**Subject: CZ-19-0859-42 – Design Build Construction of Heating, Ventilation, and Air Conditioning (HVAC) at Multiple Sites – Package B (SDUSD Project #91030071.1)**

**Notice to Proceed: No. 14R1 – MDF Room at Field Elementary School**

**Contract No:** CZ-19-0859-42 **Subject:** Added MDF Room (Additional Scope- Pathways through Fire Rated Walls)

<b>1. SUBMITTAL TYPE: (Is this a resubmittal? Yes <input type="checkbox"/> No <input checked="" type="checkbox"/>)</b>				
Deferred Submittal	Addendum Number:	Revision Number:	CCD Number: 025	Category A <input type="checkbox"/> or B <input checked="" type="checkbox"/>
<b>2. PROJECT INFORMATION:</b>				
School District/Owner: San Diego Unified School District			DSA File Number: 37 58	
Project Name/School: Field Elementary School			DSA Application Number 04 115931	
<b>3. APPLICANT INFORMATION:</b>				
Date Submitted: 07/14/20		Attached Pages? No <input type="checkbox"/> Yes <input checked="" type="checkbox"/> Number of pages? 8		
Firm Name: StudioWC Architecture + Engineering		Contact Name: Robert Webb		
Work Email: bwebb@studlowc.net		Work Phone: (760) 753-6800		
Firm Address: 515 Encinitas Blvd Suite 201		City: Encinitas	State: CA	Zip C

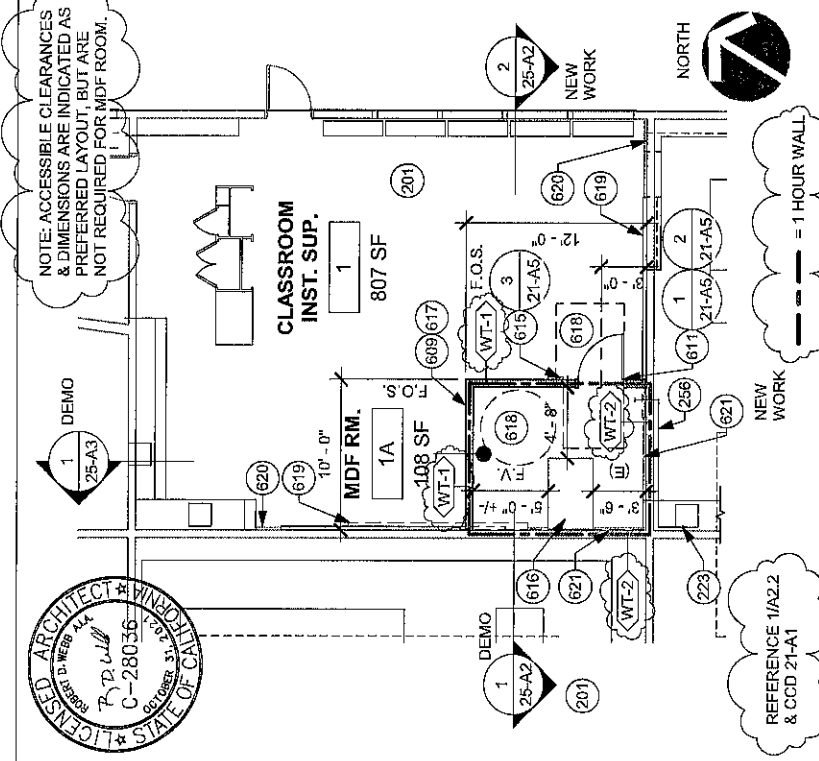
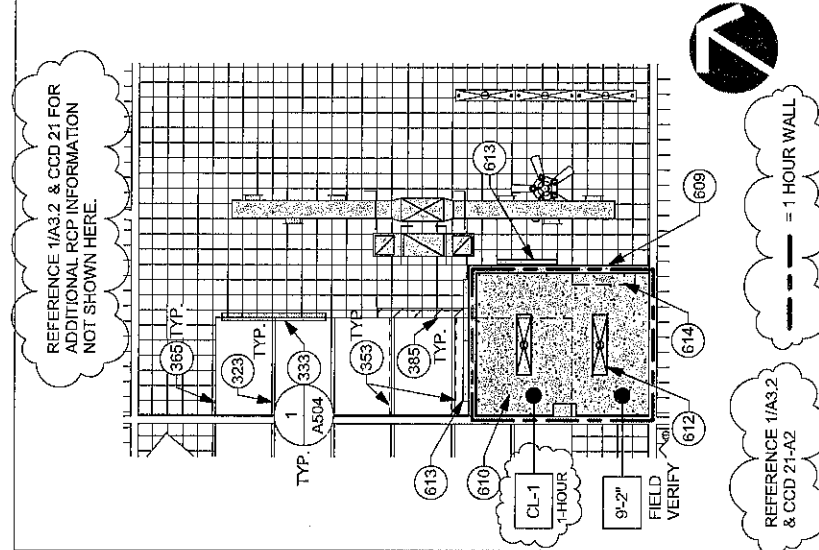
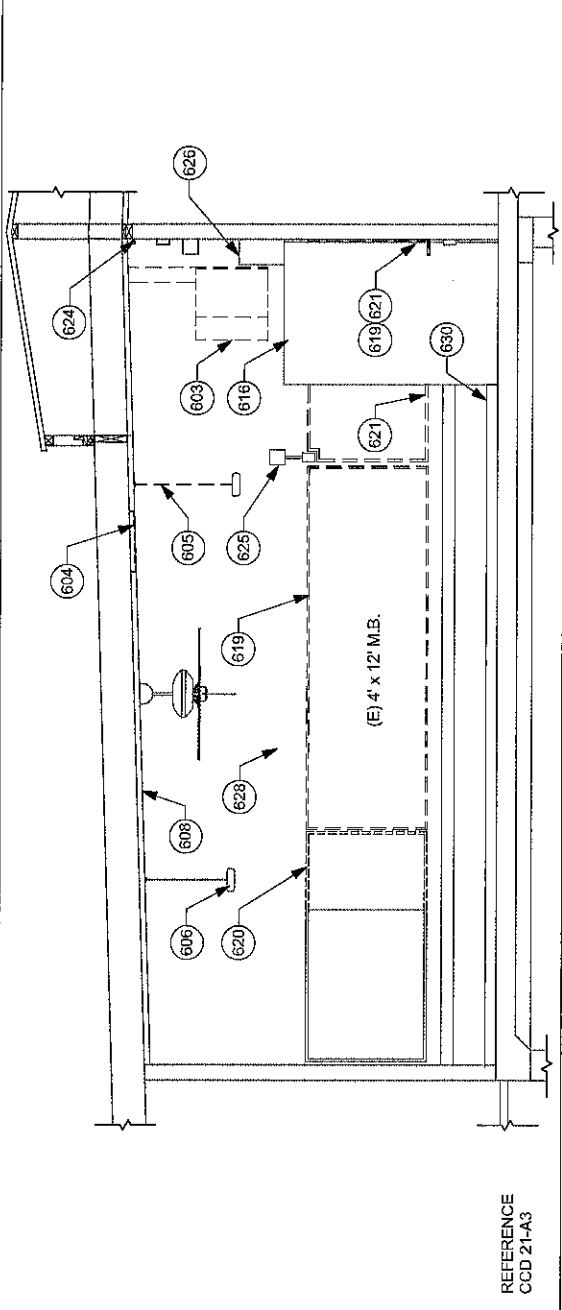
Signature:  _____ DESIGN PROFESSIONAL IN GENERAL RESPONSIBLE CHARGE				
<b>6. CONFIRMATION, DESCRIPTION AND LISTING OF DOCUMENTS:</b>				
For addenda, revisions, or CCDs: CHECK THIS BOX <input checked="" type="checkbox"/> to confirm that <i>all</i> post-approval documents have been stamped and signed by the Responsible Design Professional listed on form <i>DSA 1: Application for Approval of Plans and Specifications</i> for this project. (For <i>Deferred Submittals</i> , refer to <i>IR A-18: Use of Construction Documents Prepared by Other Professionals</i> , and <i>IR A-19: Design Professional's Signature and Seal (Stamp) on Construction Documents</i> , when applicable, for signature and seal requirements.)				
Provide a brief description of construction scope for this post-approval document (attach additional sheets if needed): Per District request, revise issued CCD 021 to provide 1 Hour Rated enclosure at new MDF Room per attached CCD 25-A1 thru CCD 25-A5, and per FBA Memorandum and CCD 25-E1 & CCD 25-E2.

List of DSA-approved drawings affected by this post-approval document: CCD 021, CCD 023, A2.2, A3.2, A4.1, E2.2

- 609 (N) 2X6 1-HOUR FRAMED WALL W/ 5/8" TYPE X DRYWALL FINISH (PAINTED) BOTH SIDES W/ R19 INSULATION. INSTALL 5/8" UL RATED PLYWOOD @ MDF RM. SIDE OVER DRYWALL FINISH. PAINT TO MATCH. FIRE SEAL/ CAULK ALL PENETRATIONS. SEE 5/E0.4 FOR FIRE STOPPING DETAIL.

- 610 (N) 2X6 FRAMED CEILING W/ 2 LAYERS OF 5/8" TYPE X DRYWALL FINISH (PAINTED) AT UNDERSIDE OF CLG. & R19 INSULATION. INSTALL 1/2" PLYWOOD AT TOP OF JOISTS FOR ABOVE CEILING ACCESS SURFACE. FIRE SEAL/ CAULK ALL PENETRATIONS. SEE 5/E0.4 FOR FIRE STOPPING DETAIL.

SHEET NO.  
**CCD 25-A4**

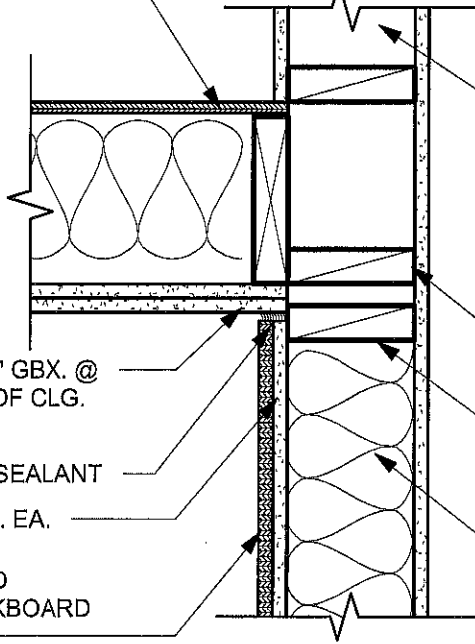
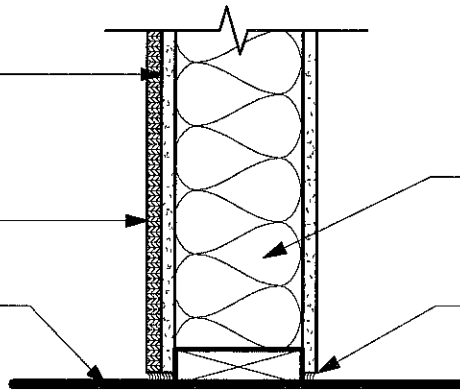
1 HR. RATED WALL ASSEMBLY  
CBC TABLE 721.1(2) ITEM 15-1.12  
PROVIDE RATED ASSEMBLY **ONLY** AT LOCATIONS INDICATED ON FLOOR PLAN

MDF RM. @ CLASSROOM 1 ELECTRICAL PLAN

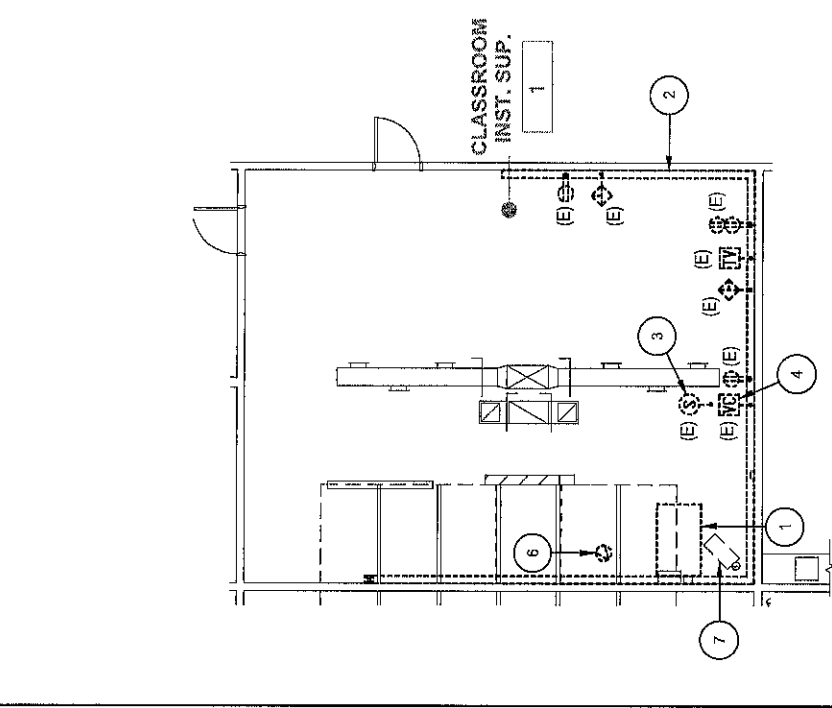
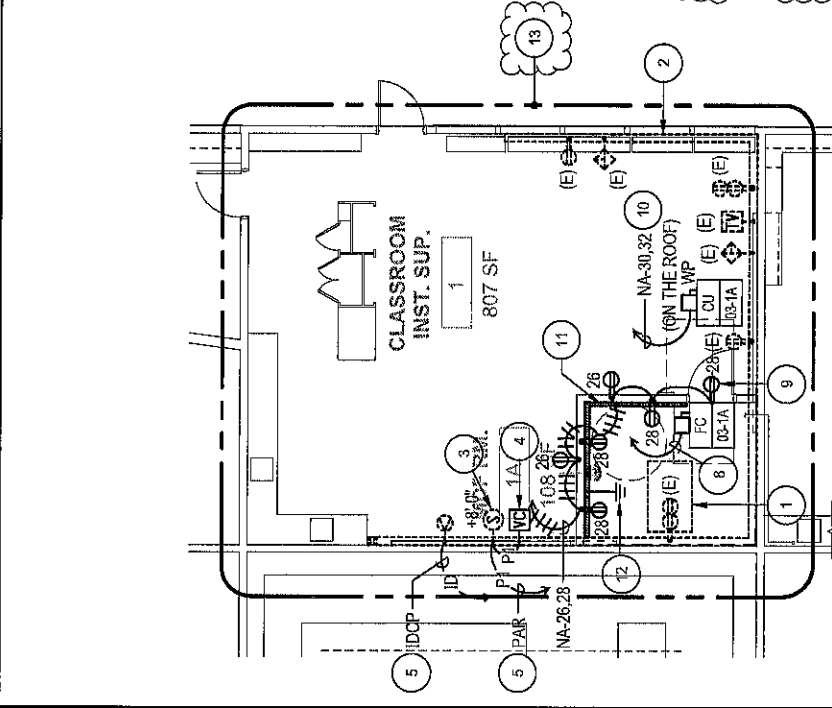
1. Reference Sheet CCD23-E2
  - a. Revise sheet per attached Drawing CCD25-E1.
2. Reference Sheet CCD25-E2
  - a. Add Sheet EED25-E2 in its entirety.

- 7 DISCONNECT AND REMOVE POWER FROM EXISTING FURNACE.
- 8 PROVIDE 3/4" C. 2#10, 1#10 GRD. AND INTERCONNECT FAN COIL TO UNIT CU-03-1A LOCATED ON THE ROOF. VERIFY EXACT LOCATION AND MANUFACTURER'S REQUIREMENTS WITH MECHANICAL DRAWINGS.

- 12 PROVIDE 3/4" C. -#6GRD. TO BUILDING GROUNDING SYSTEM.
- 13 REFER TO SHEET CCD25-E2 FOR REVISION TO EXISTING WIREMOLD 5400 RACEWAY.
